Sketch showing 3 x 6 KW. Liston Bruston Automatic plants set down with relations to equipment supplied with them. Engine room should be 14 x 20 feet and line shaft directly over centre of plants.

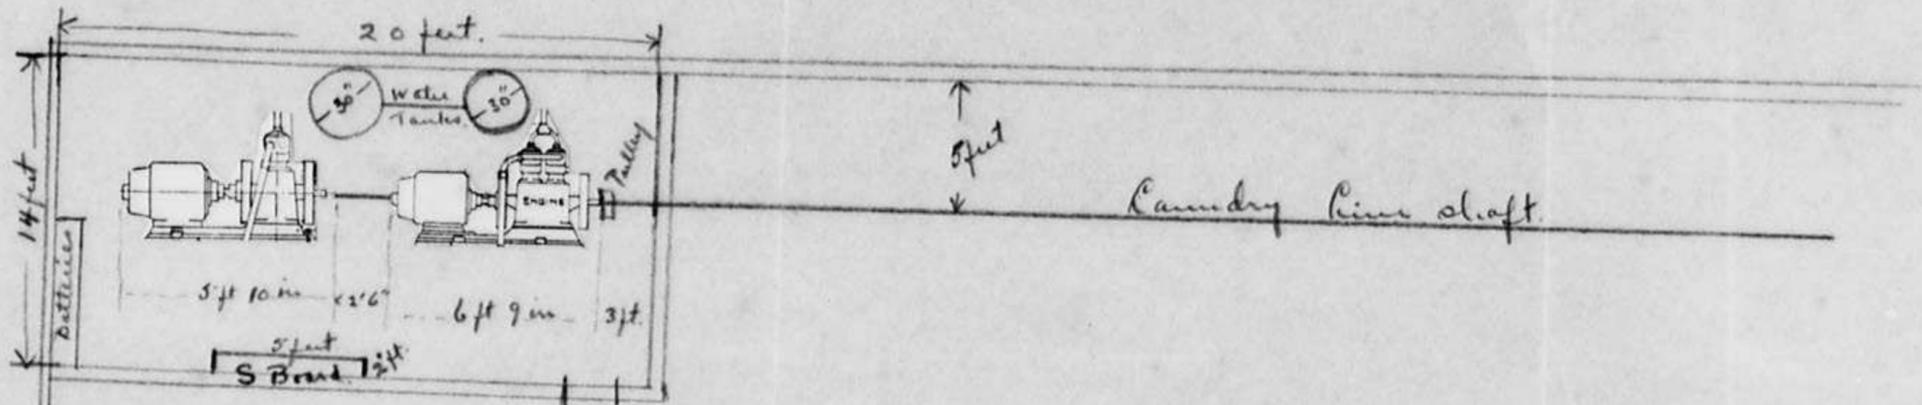
You ask what our recommendation is in the driving of a Laundry and might say we will not consider putting our plants up against a motor driven load for this work. We have found in every instance where we have done your work that the handling of a laundry machine is in the hand of inexperienced persons and if an electric motor were used for this work there would be times when the motor would be driven off the battery instead of having the plant running to supply the necessary current. This discharge for a 3H.P. motor taken from the battery until the plants got started, would eventually ruin the battery and on every laundry drive which we have hooked our engines up to, 3H.P. has not been adequate to drive them.

We might say the Edmonton Laundry, when in operation, takes from 5 to 5½H.P. Our other reason for preferring mechanical drive from the engine is that when the laundry is running, the engine can be used at the same time to give the required overcharge to the battery, thereby doing both these jobs at one time and safe-guarding your battery instead of taking the discharge from it.

We have been handicapped on the most of our jobs by making our machines fit the room and the line shaft drive and the opportunity which you are now giving us to place our space requirements before you is very acceptable. In the engine room shown on the plan which you sent us a line shaft will be running parallel with the long way of the laundry and will be running parallel with the short way of the engine room. This means that we have to place our plants then one behind the other which makes a more expensive installation and consequently is more costly to the department as it takes more piping and fittings, etc. If the engine room were placed the long way the same as the laundry, then our plants would be put end to end, making a cheaper method of installation and a belt would go from the pulley on the engine straight up to the pulley on the line shaft, instead of on the slant, thereby obstructing the movements of the operator around the machine. To make this a little clearer, we are making a drawing showing what we consider an ideal arrangement for this type of plant. However, on the other hand this might not suit your building requirements and we want to co-operate with you making any alterations which you would prefer and any suggestions we can offer we will be glad to do so and trust to hear from you further in reference to this. The dimensions of the engine room especially if a pump is to be located in the engine room requires to be 20 feet long by 14 or 15 feet wide.
